Re: Bayshore Pines RPD
DCI2022-00048
Resubmission 3

Below is our response to the letter of review dated January 24, 2023. We are addressing each comment below for clarification.

Bayshore Pines RPD
DCI2022-00048
1-24-23 MCP Revisions

BAYSHORE PINES RPD BIG LLC MASTER CONCEPT PLAN

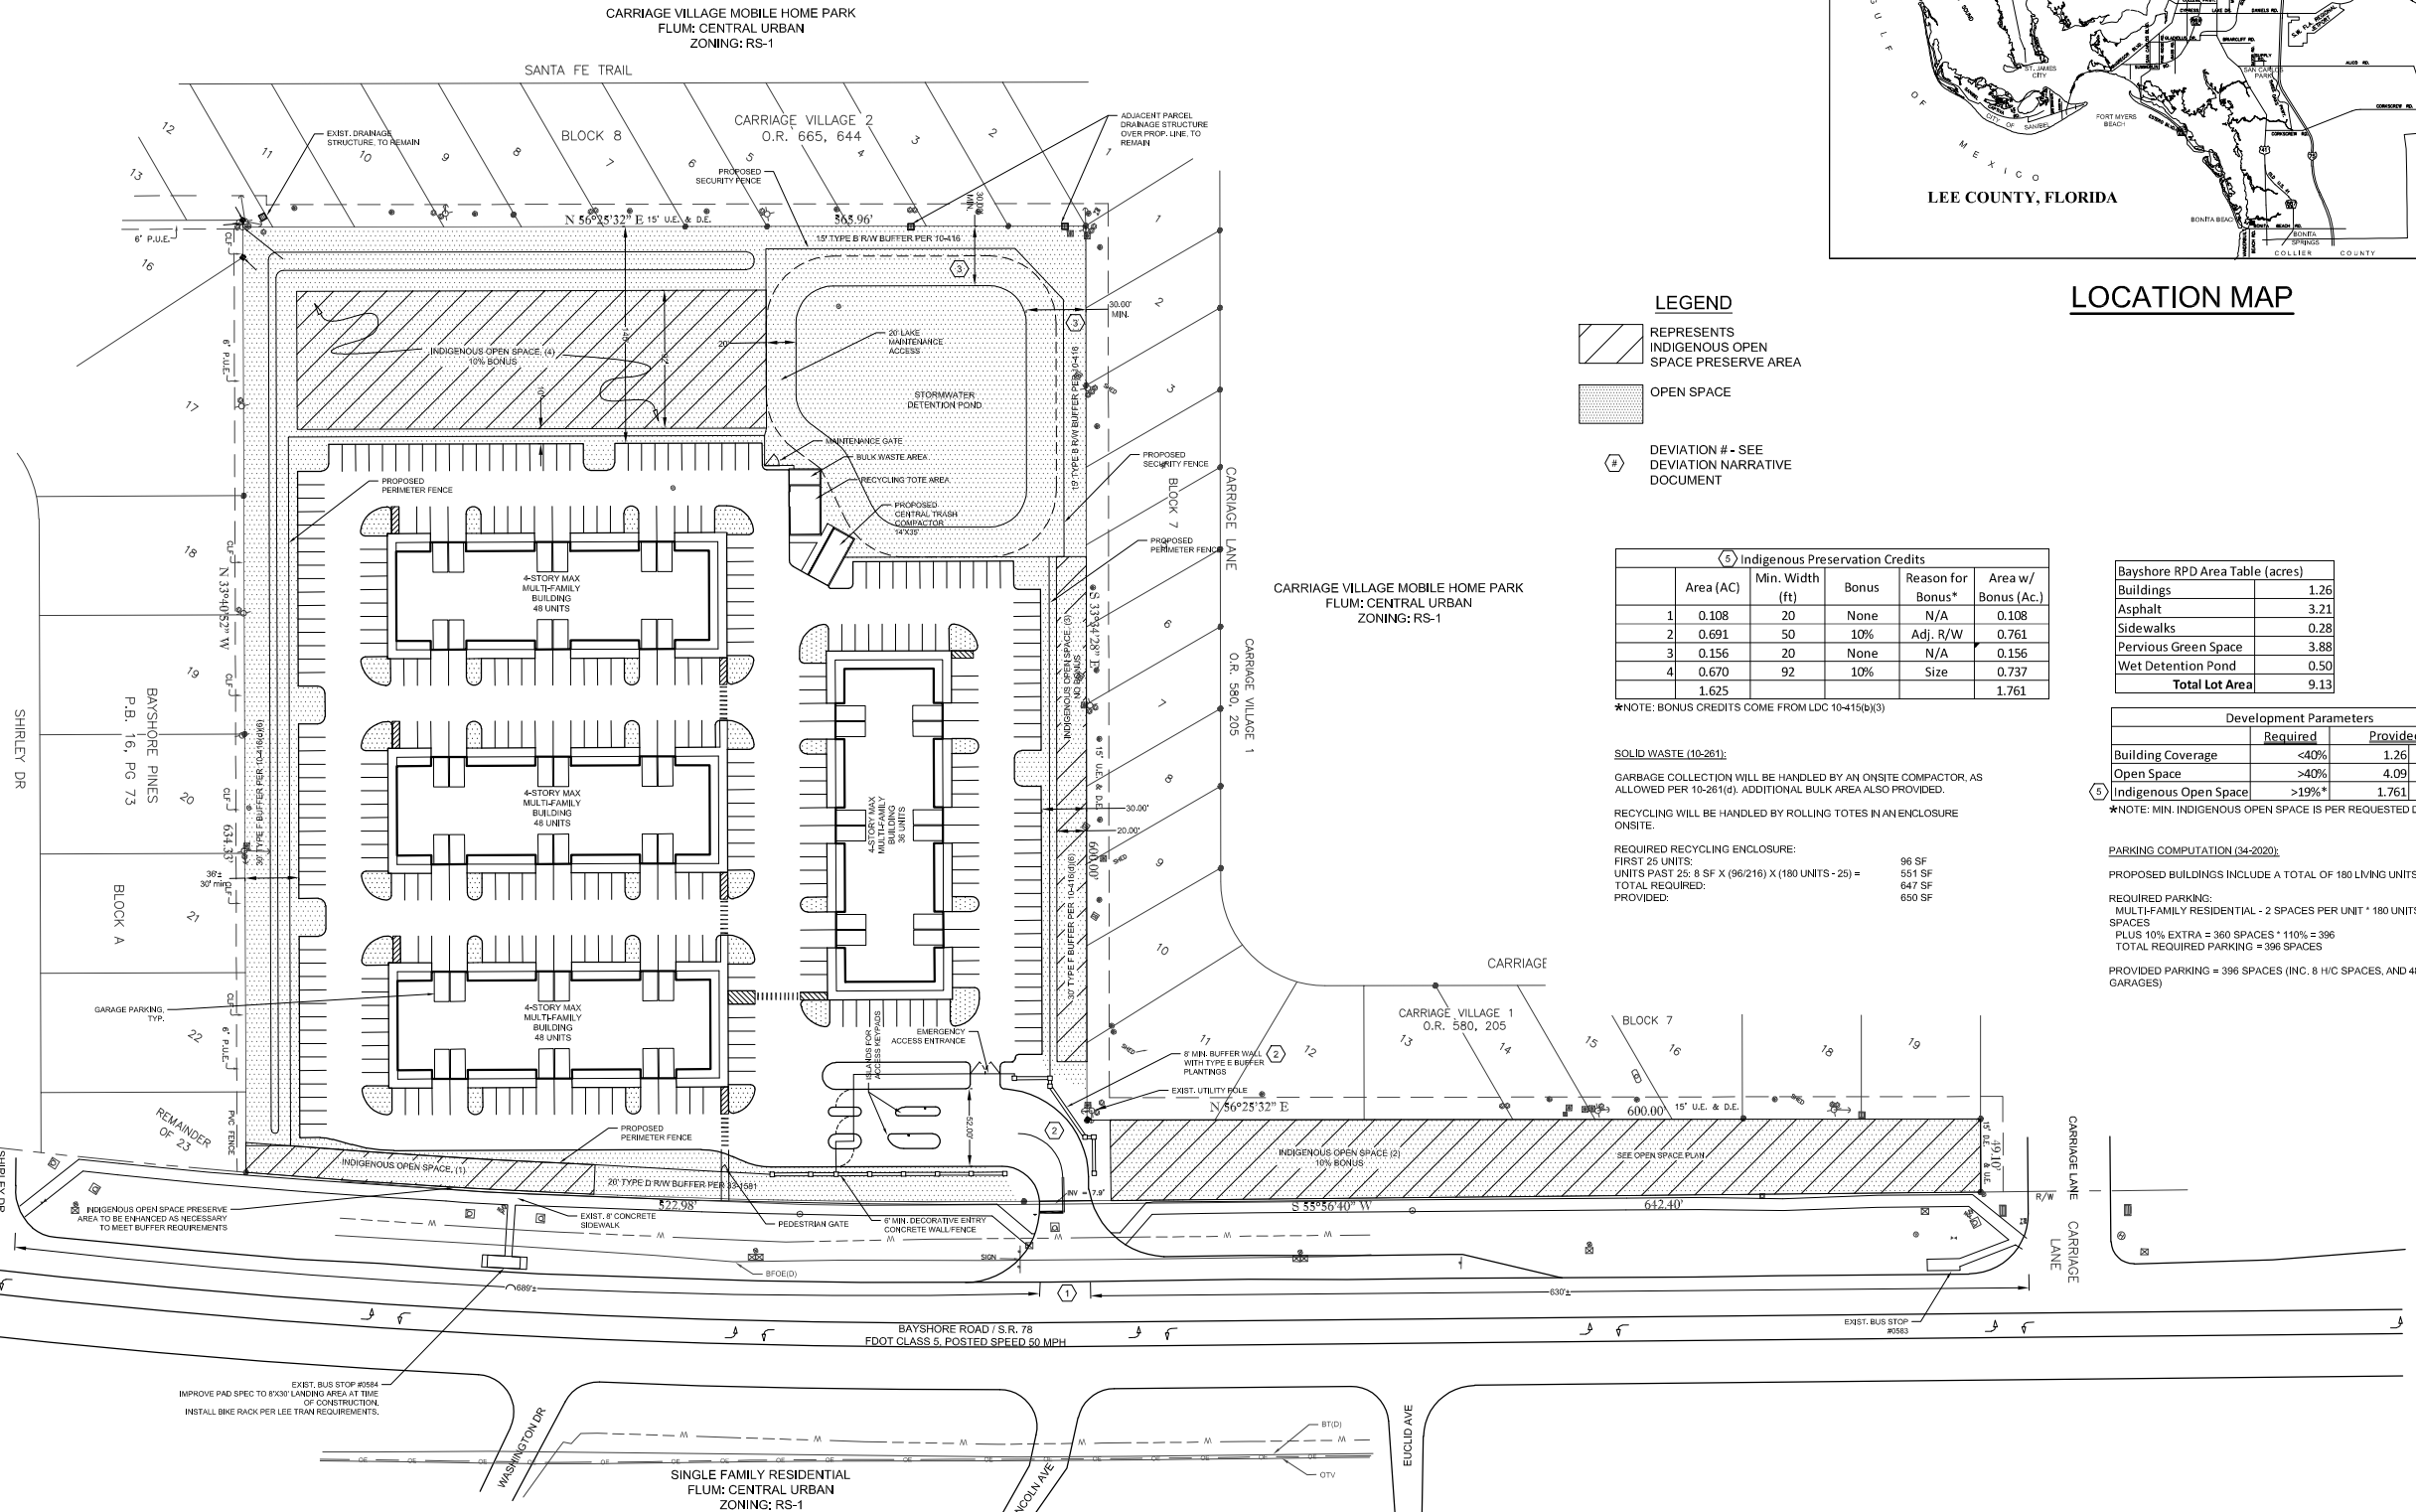
The indigenous preservation credit chart (area 1) does not meet the minimum width or acreage to receive a 10% increase per LDC 10-415(b)(3). Please revise the chart, overall open space, and the requested deviation.

Please note that we have a different interpretation of LDC 10-415(b)(3)b than staff. Our belief is the 10% credit under this section is available as a separate credit from the credits also available under paragraph LDC 10-415(b)(3)a. This credit was previously depicted for indigenous area 1 both on the initial application submission and on the first resubmission without comment from staff. However, it does not matter in this case since the credit was small and the requested Deviation 5 remains unchanged. The provided indigenous area is in excess of the requested 19% in Deviation 5. We have updated the MCP and the open space plan to reflect the deletion of the credit for Indigenous Area 1. I am highlighting the very few revisions to the MCP needed in an attachment for clarity.

5 Indigenous Preservation Credits					
	Area (AC)	Min. Width (ft)	Bonus	Reason for Bonus*	Area w/ Bonus (Ac.)
1	0.108	20	None	N/A	0.108
2	0.691	50	10%	Adj. R/W	0.761
3	0.156	20	None	N/A	0.156
4	0.670	92	10%	Size	0.737
	1.625				1.761

*NOTE: BONUS CREDITS COME FROM LDC 10-415(b)(3)
